PREVOST

SAFETY RECALL

Sr09-04

DATE : FEBRUARY 2009	SECTION : 16-SUSPENSION
SUBJECT : REPLACING LOWER A-ARMS FIXING BOLTS

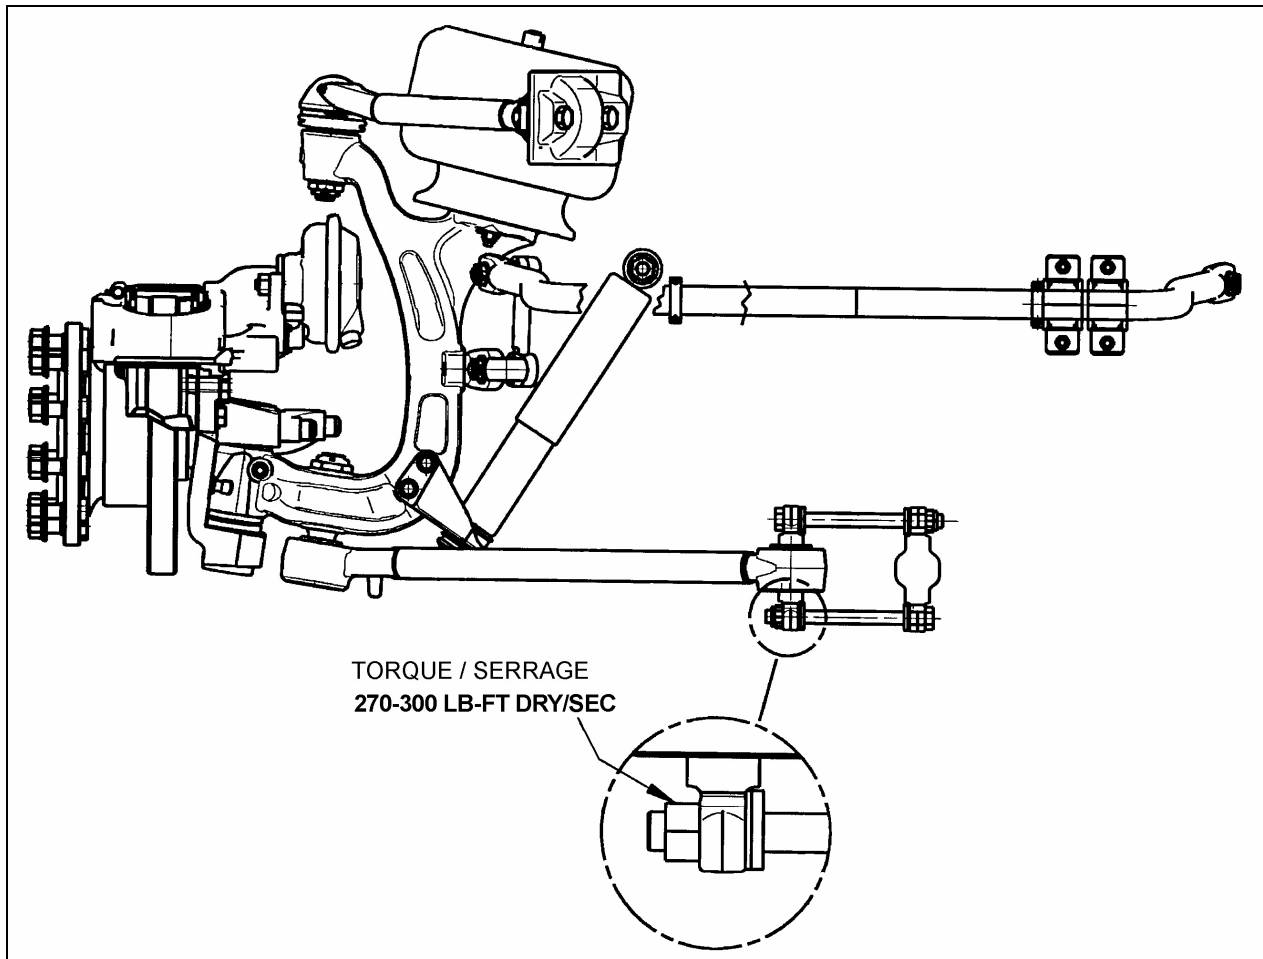
On the vehicles affected by this bulletin, it is **absolutely necessary** to verify the bolts fixing the independent front suspension lower a-arms. There is a possibility that the manufactured bolts were not of the proper quality and may break upon tightening or in use. If letters "CFS" are present on the bolt head, these must be replaced.

2. Verify what sign is present on the bolt heads fixing the lower a-arms.

3. If letters "CFS"  are engraved onto the head, the bolt(s) must be replaced with bolts having a triangular sign .

4. Torque bolts to 270-300 LB-FT dry (366-407Nm).

5. Also replace M20 Stover nuts.
